Kirby Morgan Dive Systems, Inc.®

Bulletin #14 of 2016. December 29, 2016

Maintenance & Repair Bulletin **The Stability of Whisker Clamps**

All Kirby Morgan Helmets and BandMasks® with Tri or Quad Valve Exhaust Systems, excluding the KM 47 fiberglass helmet and the KM 77 stainless steel helmet.

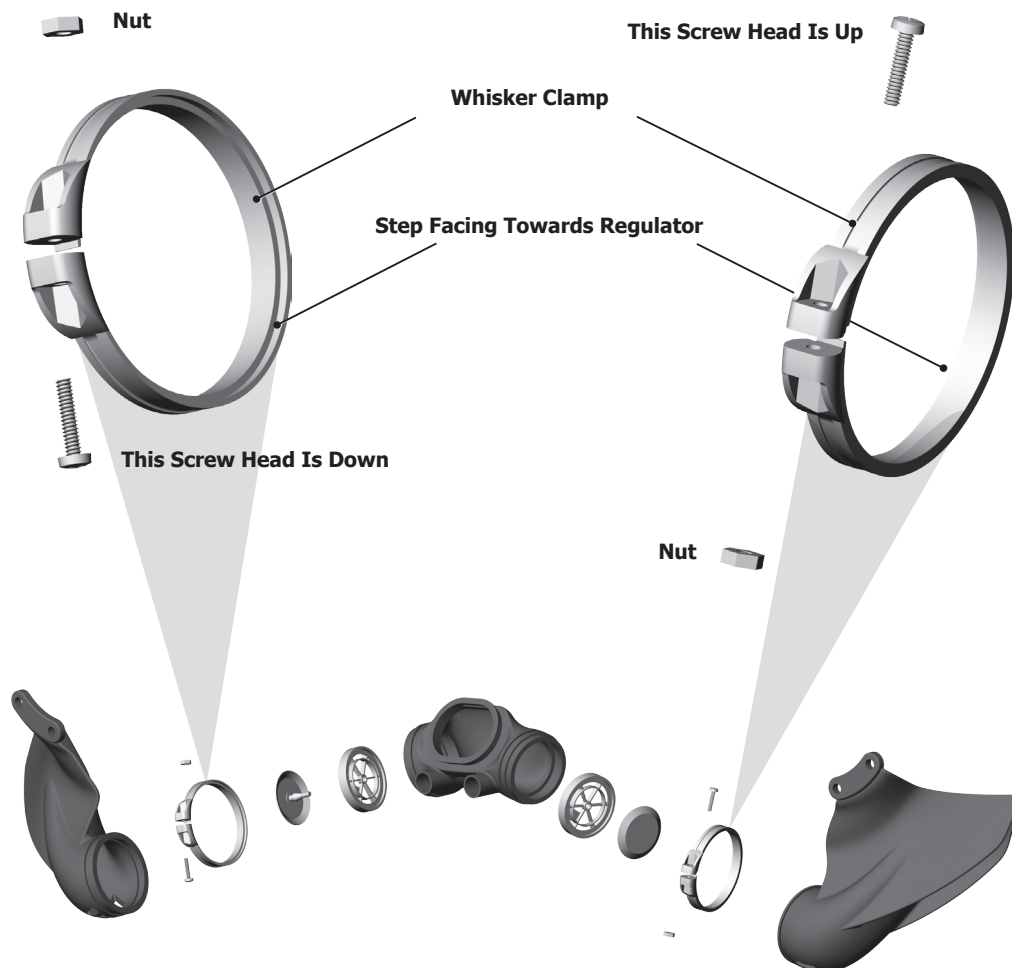
Though tie wraps are quick and easy to use, tie wraps should **NOT** be substituted for whisker clamps.

The function of the Whisker Clamp is to hold the whiskers/whisker wings to the main whisker body. Whisker Clamps became standard August 2006 as an upgrade from tie wraps. Order P/N 525-032 Whisker Clamp Replacement Kit.

Whisker Clamps provide a grip superior to that of the tie wrap and will help to ensure a dry exhaust system.

It is permissible to temporarily use Tie Wraps to hold the whiskers *only* when clamps are missing or damaged, or do not have the correct screw or nut for a proper fit up.

When clamps are lost, damaged or missing parts, and tie wraps must be used to hold the whiskers, ***check them regularly*** before and after each dive to be certain they are holding correctly.
